Project	IEEE 802.16 Broadband Wireless Access Working Group < http://ieee802.org/16 >	
Title	Power Balancing of Beamforming/Precoding Schemes	
Date Submitted	2009-05-04	
Source(s)	¹ Hsuan-Jung Su, Chung-Pi Lee, Yu-Han Yang, Chun-Yao Chen, Wei-Shun Liao, NTU Ren-Jr Chen, Chung-Lien Ho, Chang-Lan Tsai, Zheng Yan-Xiu, ITRI	Voice: ¹ +886-2-33663600 E-mail: ¹ hjsu@cc.ee.ntu.edu.tw * http://standards.ieee.org/faqs/affiliationFAQ.html >
Re:	IEEE 802.16m-09/0021 “Call for Comments and Contributions on Project 802.16m System Description Document (SDD)” for SDD Section 11.12.1 “UL MIMO Architecture and Data Processing”	
Abstract	This contribution addresses the high PAPR issue related to MIMO beamforming/precoding and OFDM. It is suggested that a general remedy to the PAPR issue without introducing signal distortion or side information feeding forward should be considered in 802.16m. A method based on constellation shaping to balance the signal power, such that the high PAPR caused by beamforming/precoding and OFDM can be reduced, is also provided in this contribution as an example of such general remedies.

Power Balancing of Beamforming/Precoding Schemes

Figure 55 MIMO Architecture

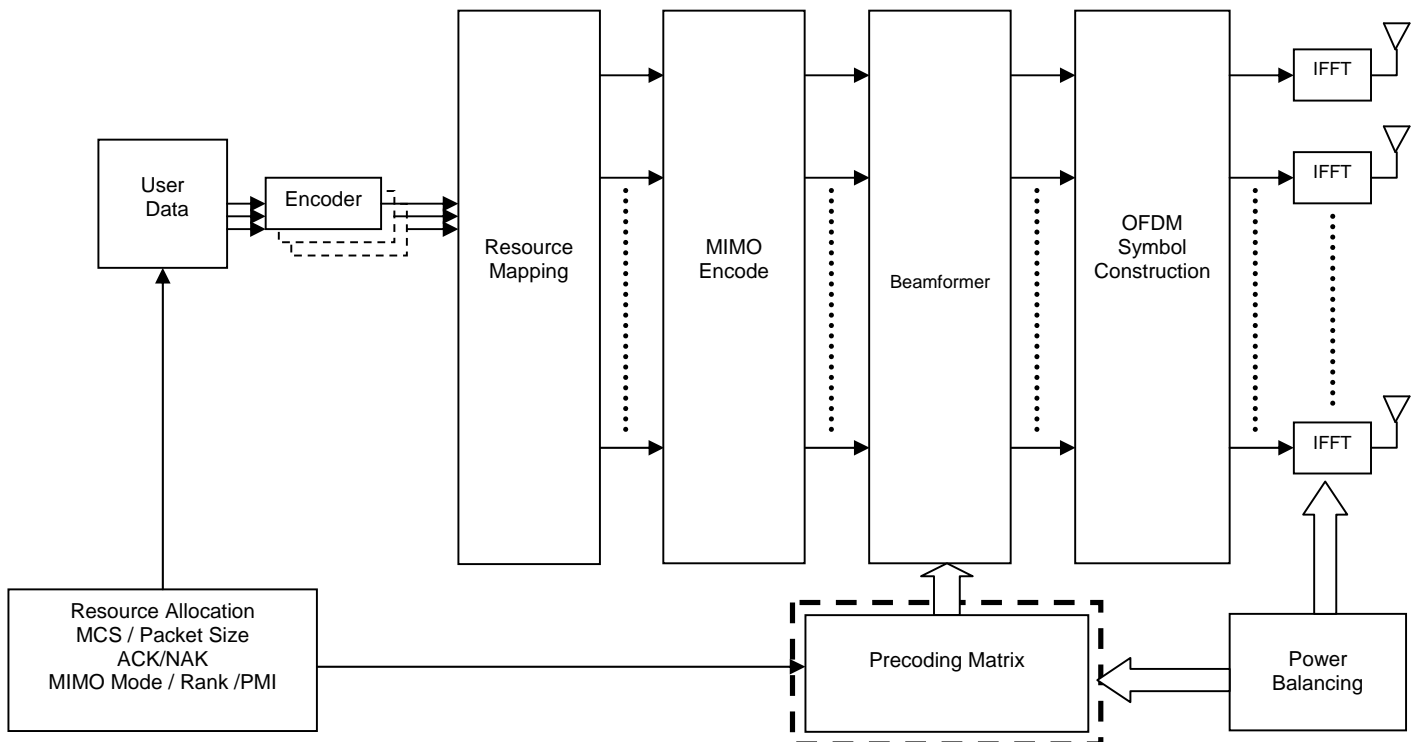
Modify Figure 55 as follows.

Figure XXX MIMO Architecture

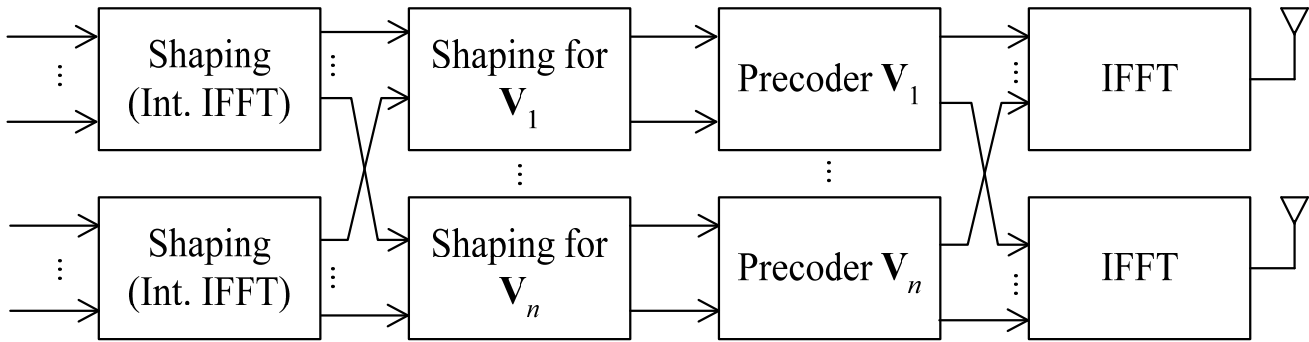
Add the following text to line 7 on page 116.

Power balancing functionality in the beamformer/pre-coder and IFFT block is optional.

The power balancing functionality should be implemented as the functional blocks shown in Figure XXX

In Figure XXX, the Shaping (Int. IFFT) blocks are designed to transform the IFFT coefficients to integer values for balancing the effects caused by IFFT blocks. The blocks named “Shaping for V_i ” deal with the effects caused by Precoder V_i to balance the power of the transmitted signal constellation.
